Kewaunee / Point Beach Nuclear  
Operated by Nuclear Management Company, LLC

NRC-02-046

Docket 50-305  
Operating License DPR-43  
Kewaunee Nuclear Power Plant  
Revision 22 of the Operational Quality Assurance Program Description (OQAPD)

QQAPD Section No. 1 (Rev. 22)  
 Figure 1 - NMC OFFSITE FUNCTIONAL QUALITY ASSURANCE ORGANIZATION

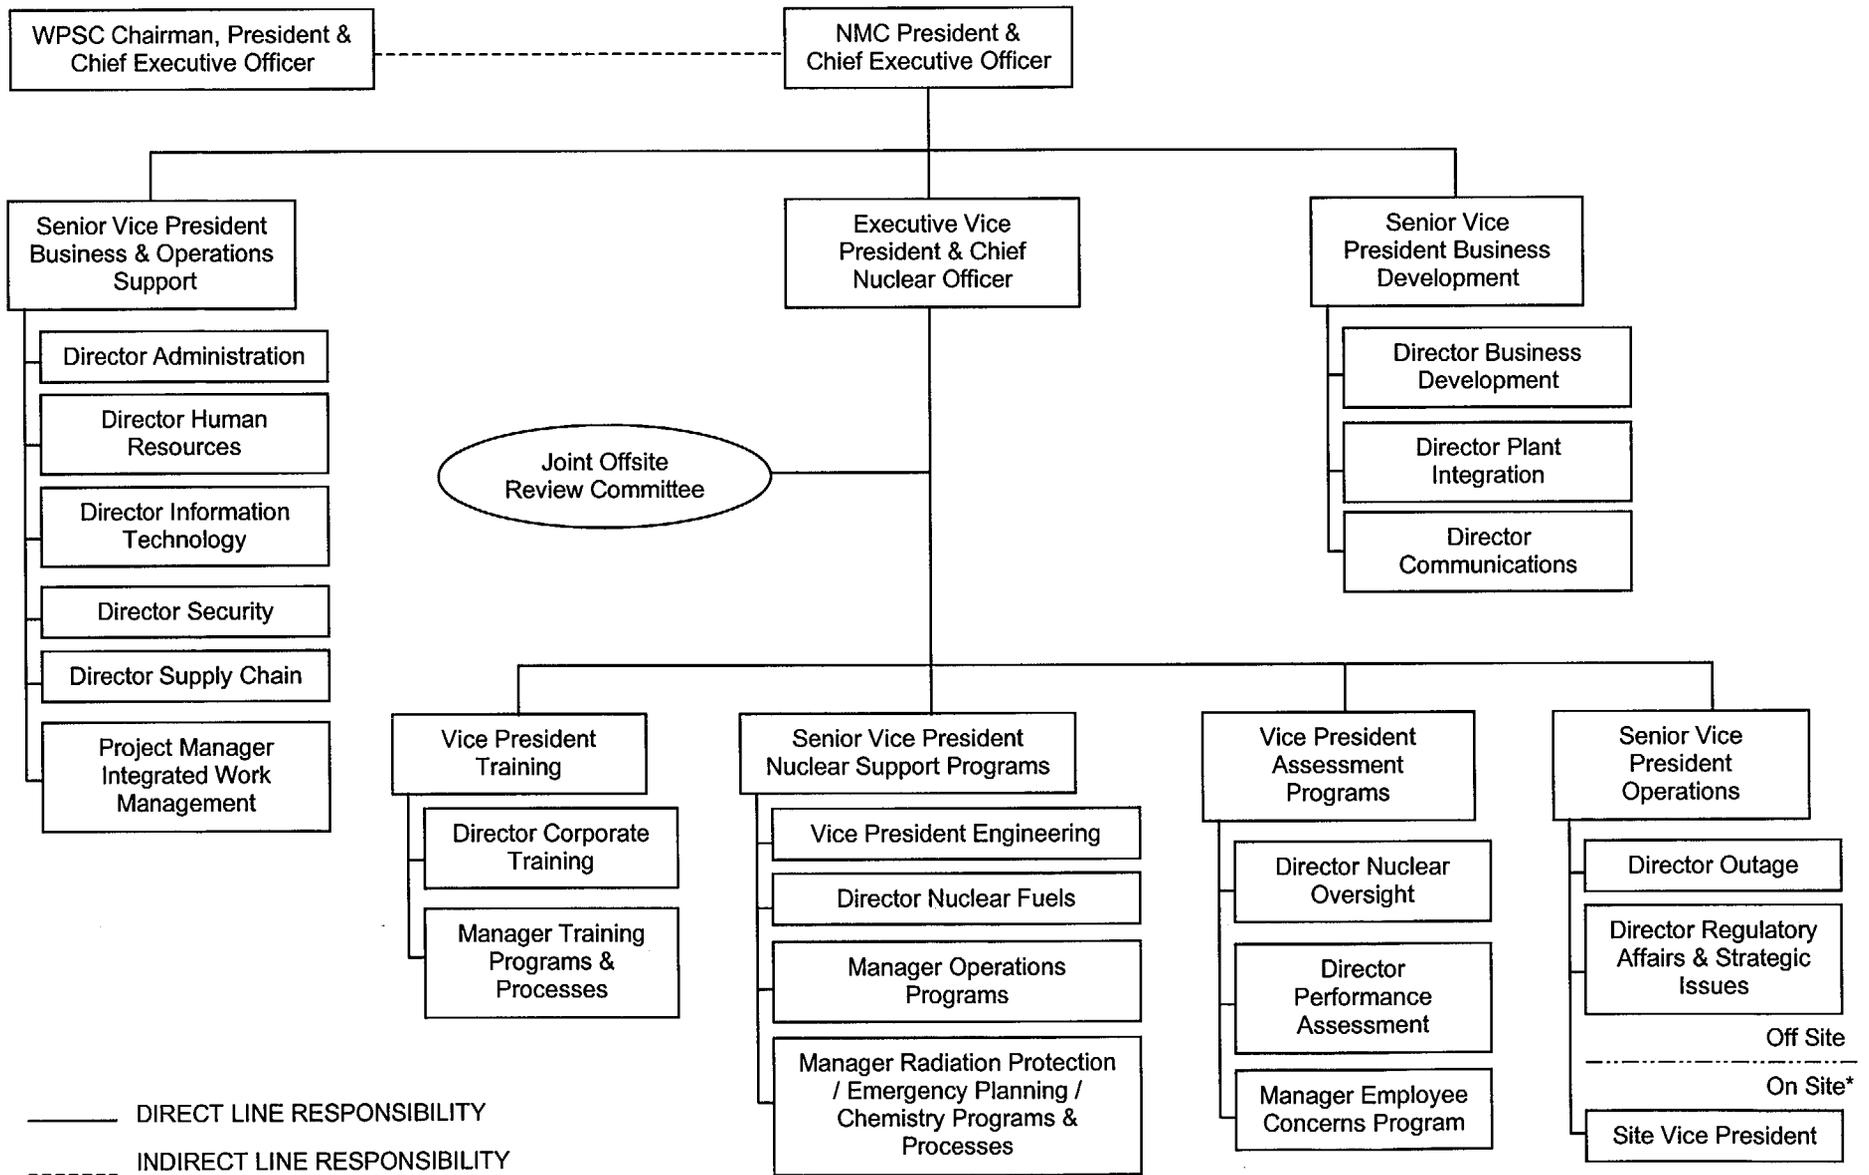
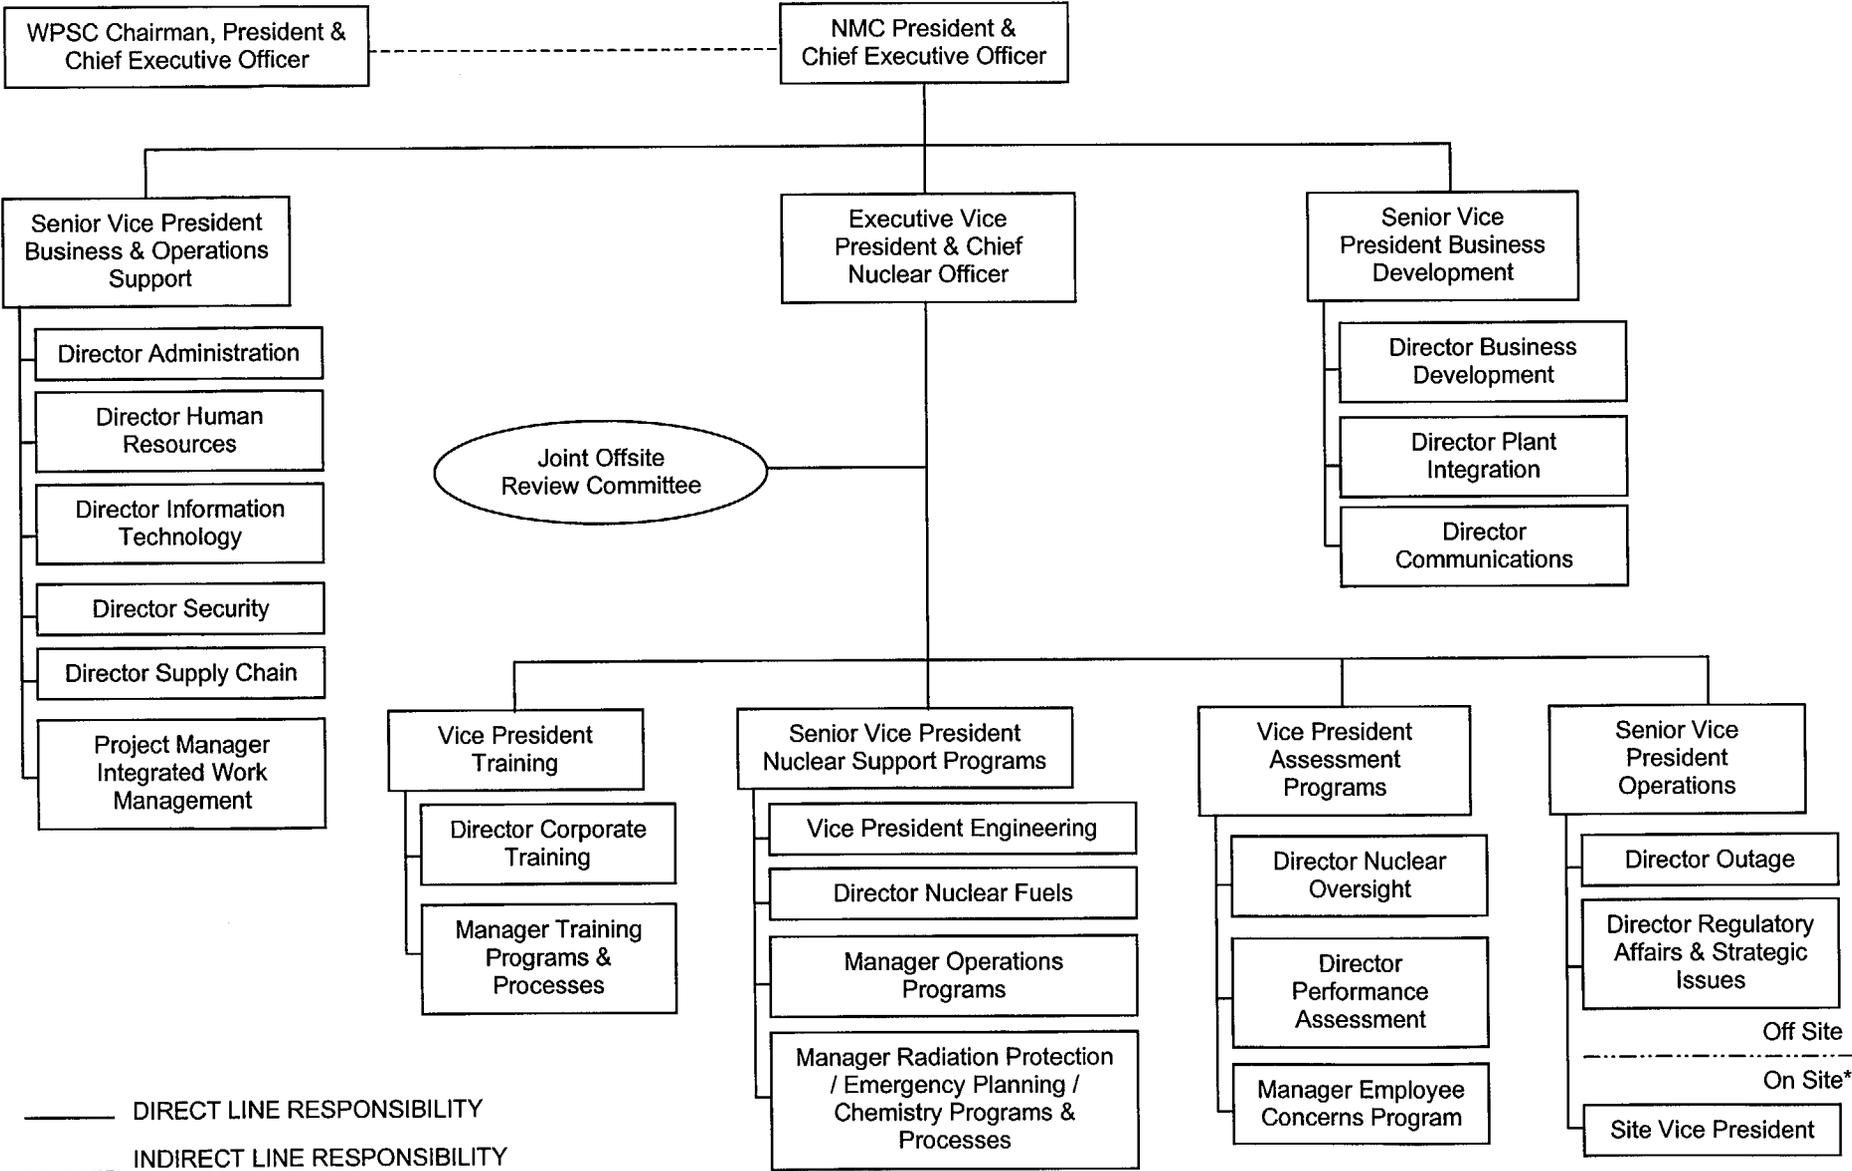
Updates to reflect current NMC organizational titles and responsibilities. The deletion of the Vice President – Treasurer & CFO from the text and Figure 1 is to remove unnecessary detail, as this position does not have any site OQAP implementing responsibilities. The insertion of the Senior Vice President – Business & Operations Support is to reflect a position that has related any site OQAP implementing responsibilities.

QQAPD Section No. 1 (Rev. 22)  
 Figure 3 - NMC ONSITE FUNCTIONAL QUALITY ASSURANCE ORGANIZATION

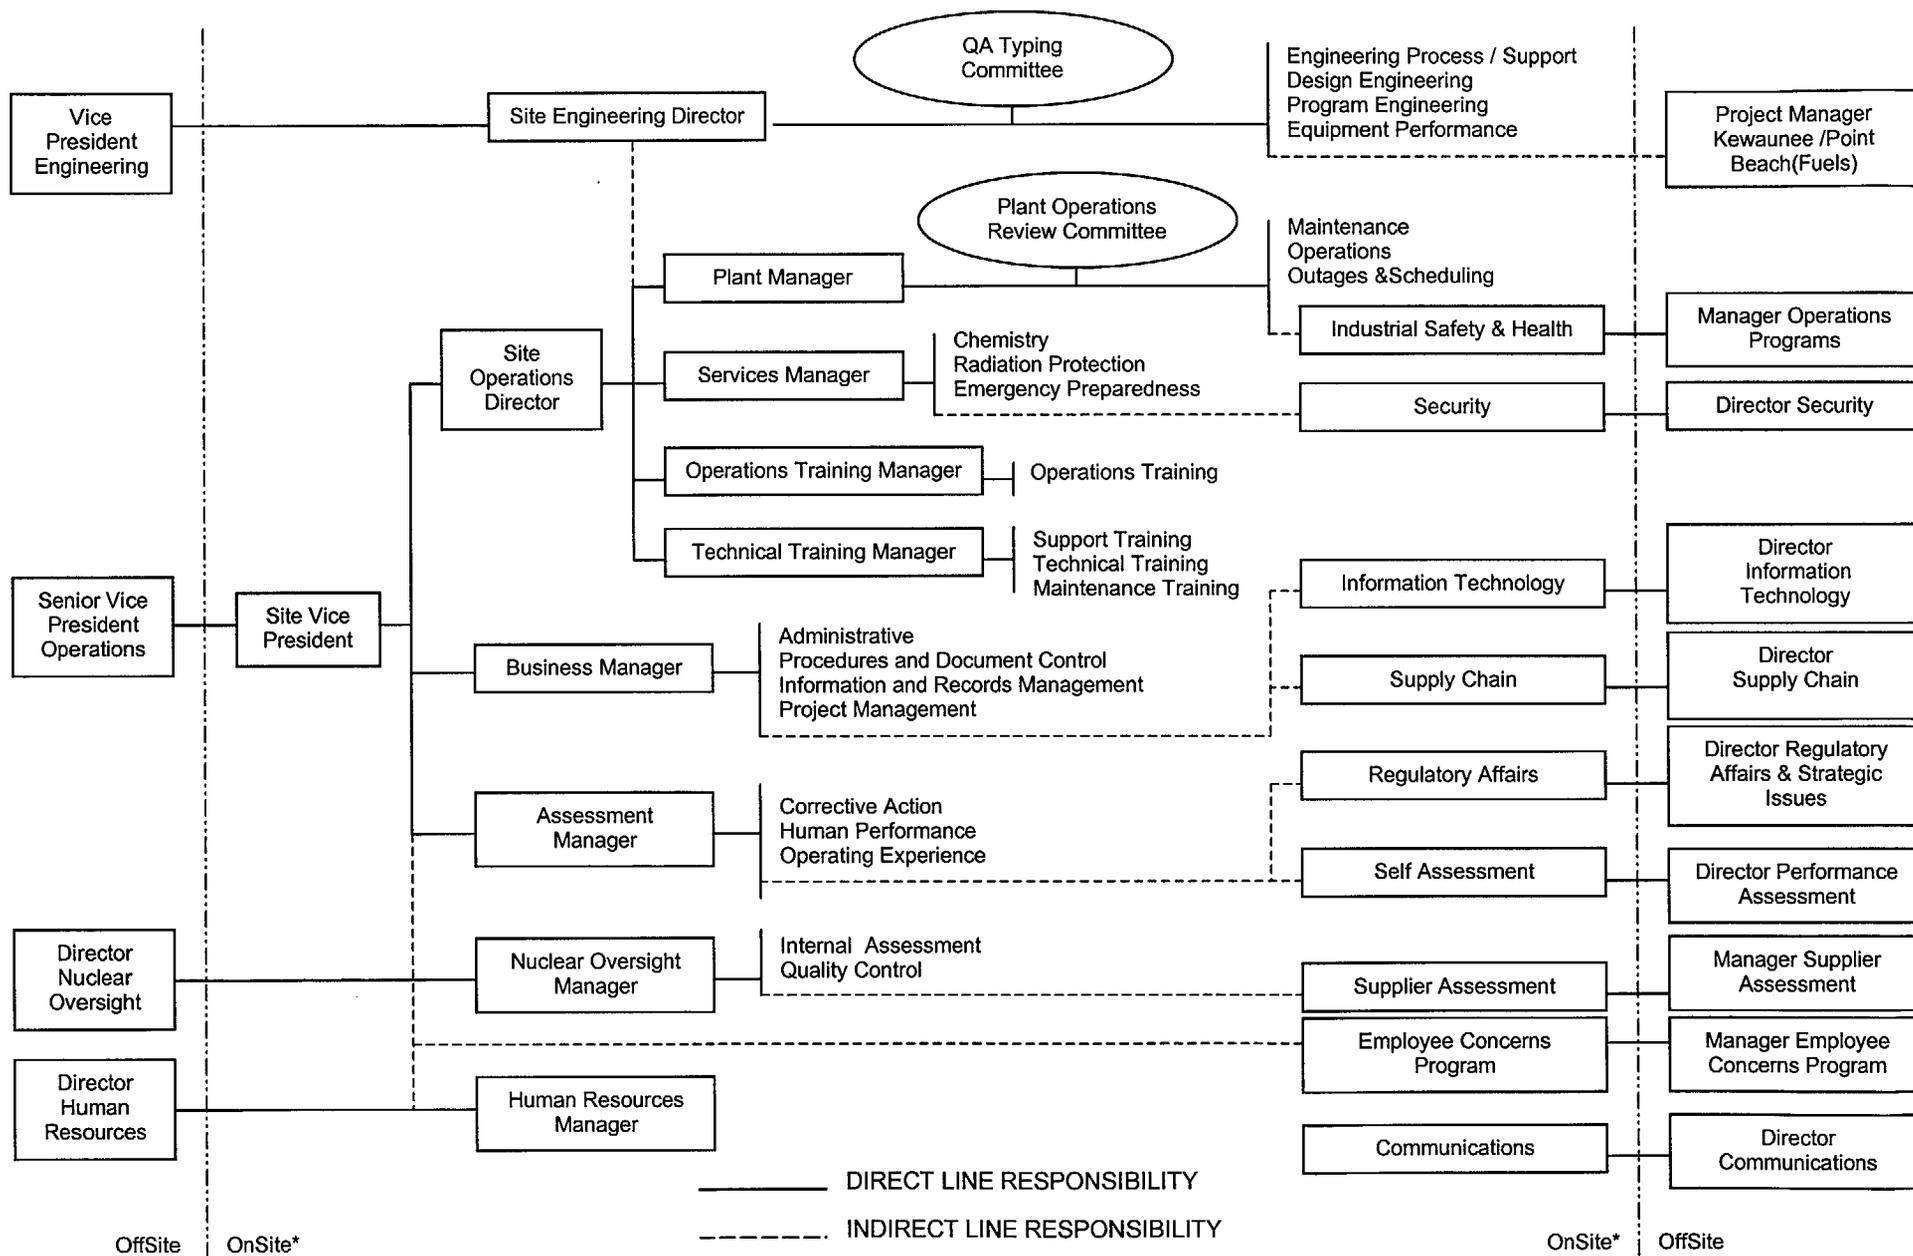
**Change “... Nuclear Management Company (Figure 3)” to “... Nuclear Management Company Onsite (Figure 3)”**

**Change “...as described below to the groups shown in Figure 3.” to “as described in the following and as shown in Figure 3.”**

Editorial change to reflect the organization’s physical location and correspond with the title of Figure 3. Updates to the organizational titles, authorities, and descriptions of responsibilities and editorial changes.
